Suite 606
OLD ORIGINAL
SUITE LAYOUT
INVENTORY SUITE

SUITE 606
NEW ORIGINAL LAYOUT
INVENTORY SUITE

*** SUITE 606 * (INVENTORY SUITE)**
NEW PLAN
-REMOVED DEN
-REVISED KITCHEN

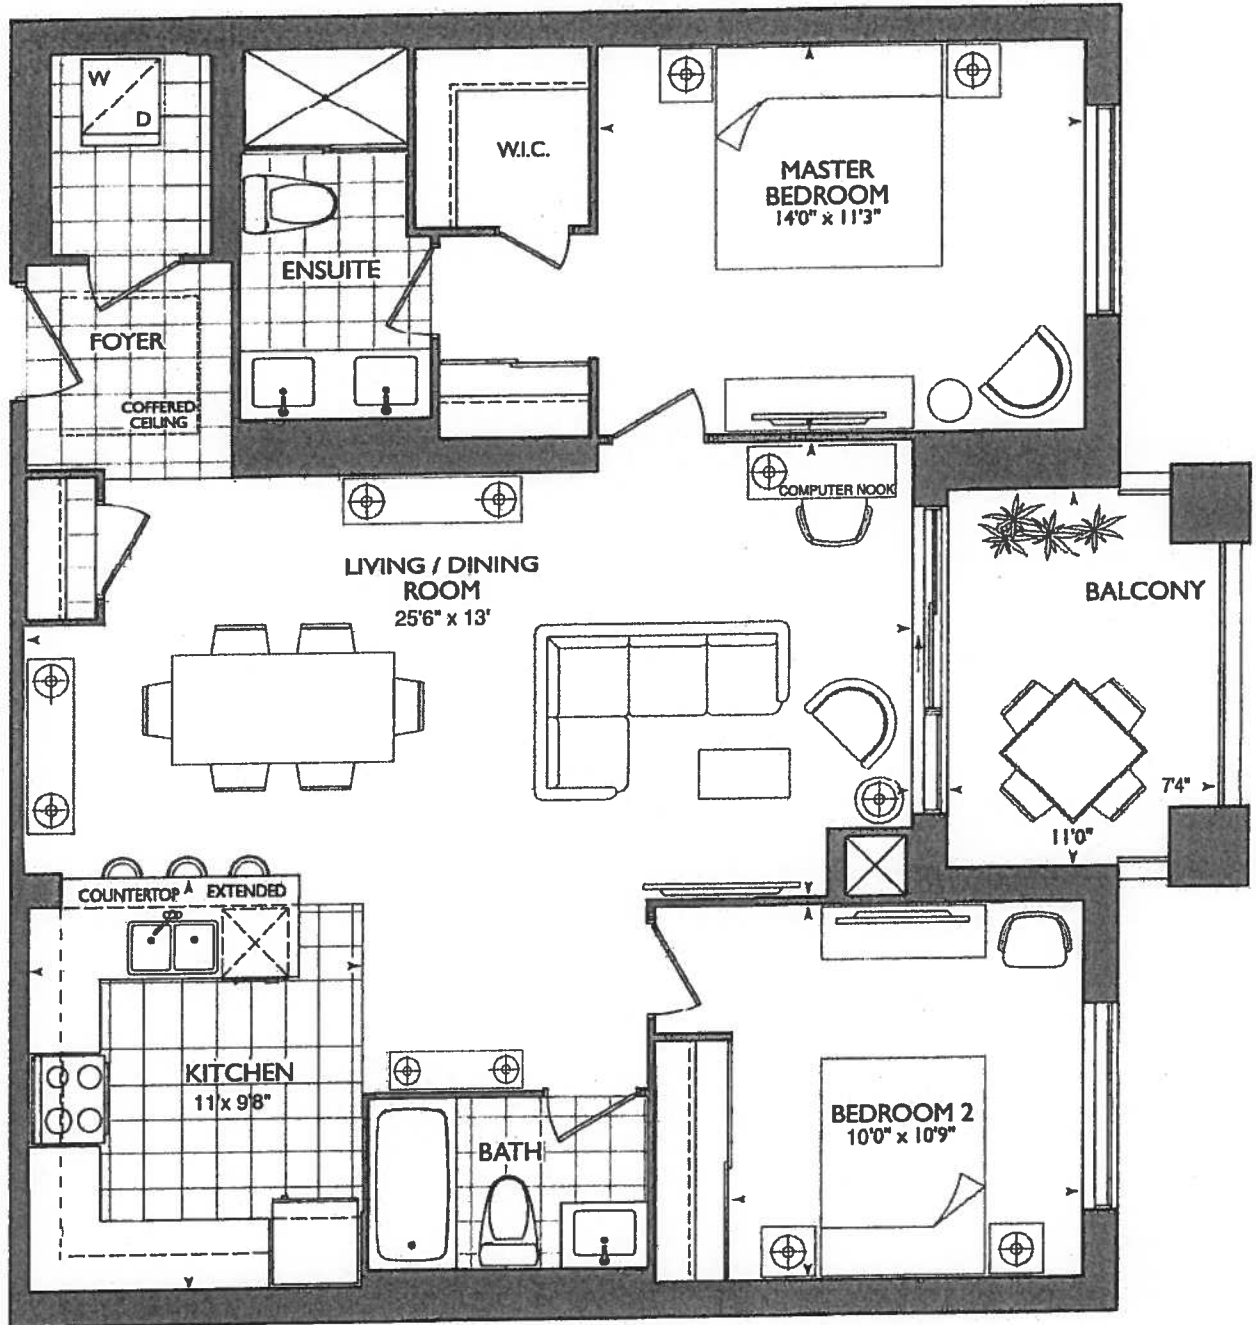
*REVISED LAUNDRY DOOR SWING &
ENSUITE WALL AS PER THIS BROCHURE

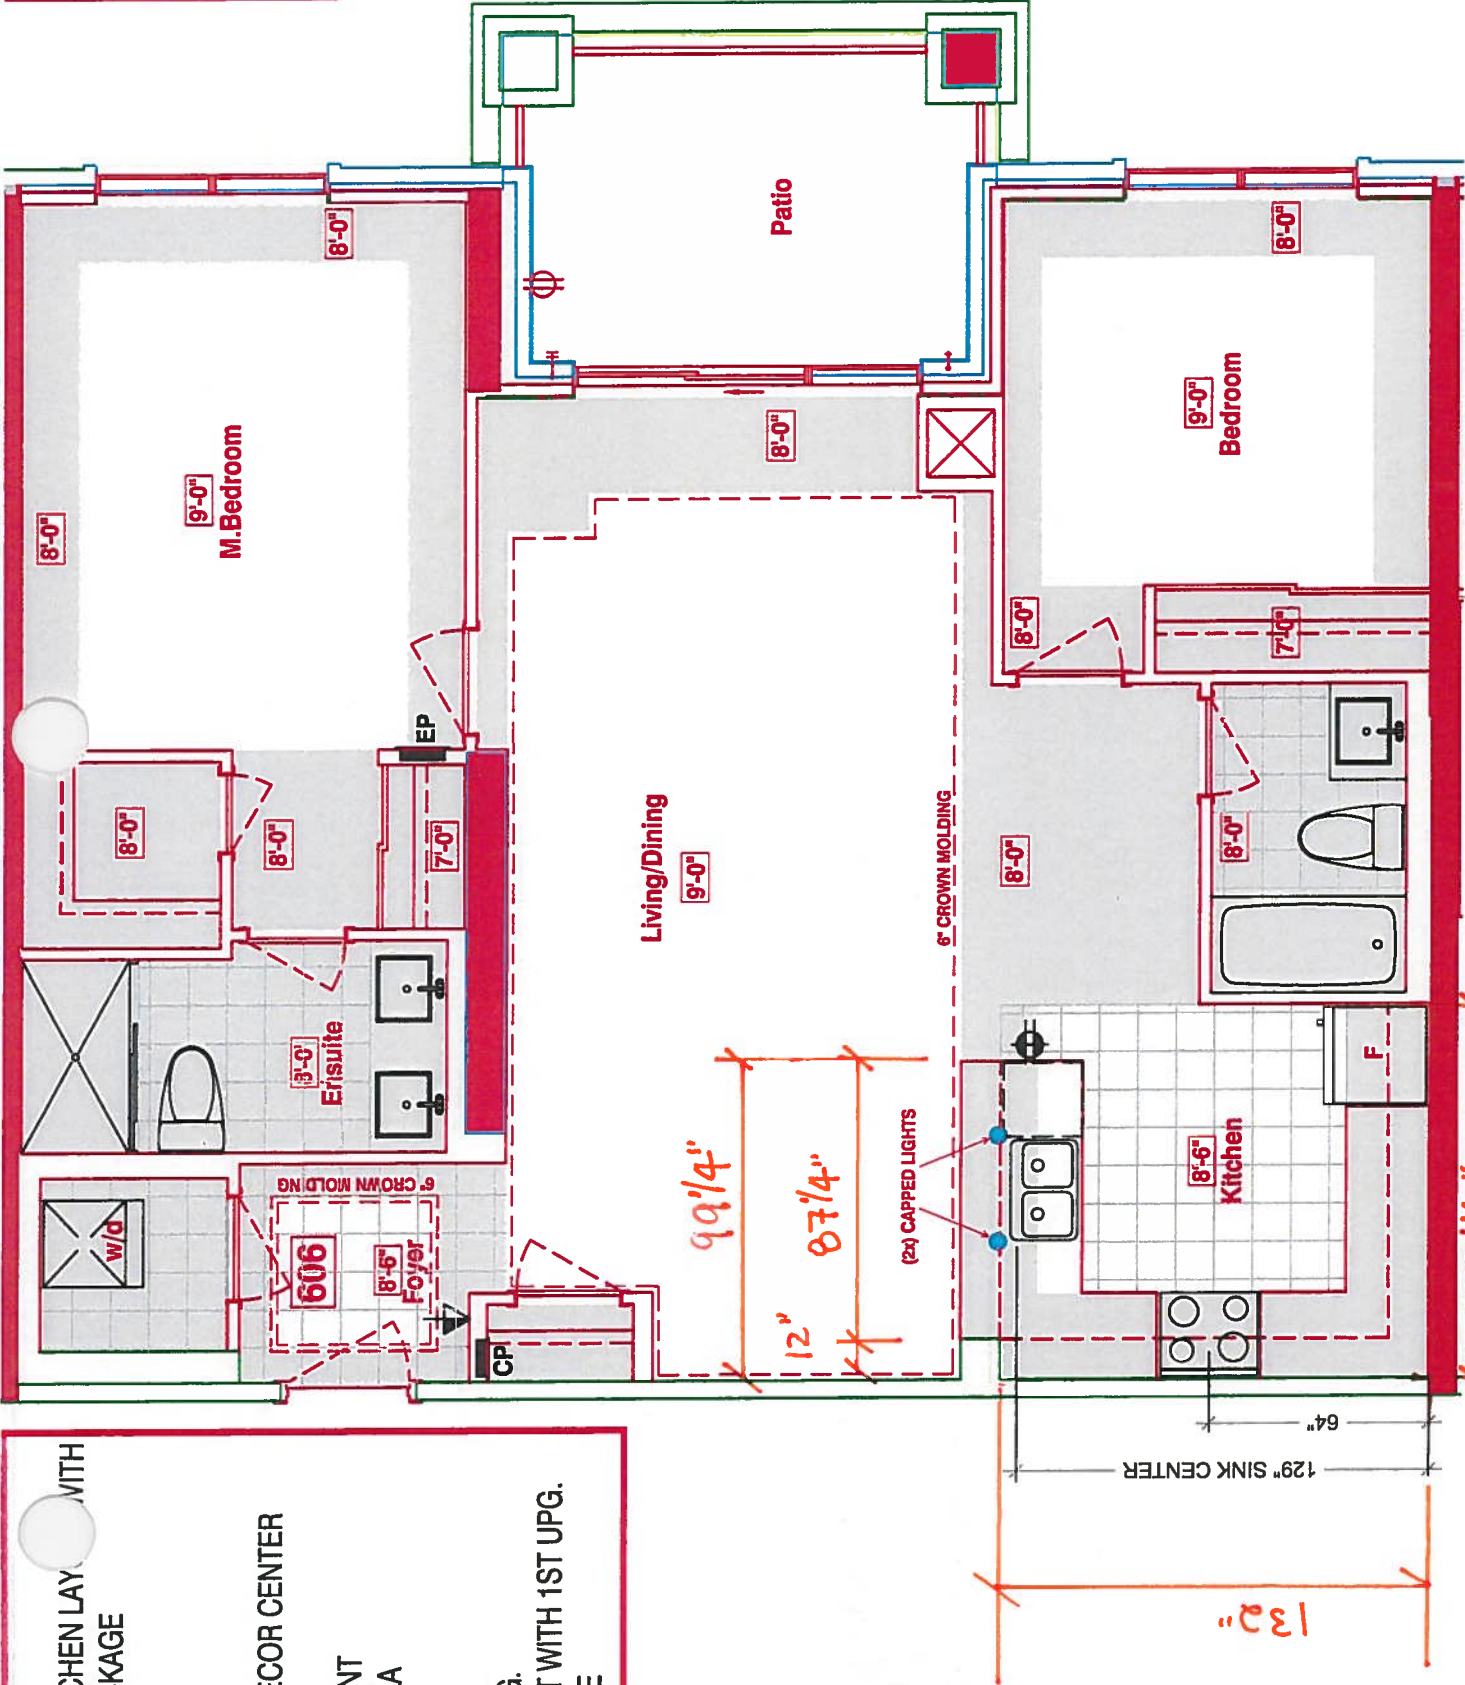
*** KITCHEN ***
CHOICE OF STD. KITCHEN LAYOUT WITH
STD. APPLIANCE PACKAGE

-(x2) CAPPED PENDANT
-(x1) PLUG PENINSULA
-(x) PUCK LIGHTS

*SEE ATTACHED UPG.
#1- KITCHEN LAYOUT WITH 1ST UPG.
APPLIANCE PACKAGE
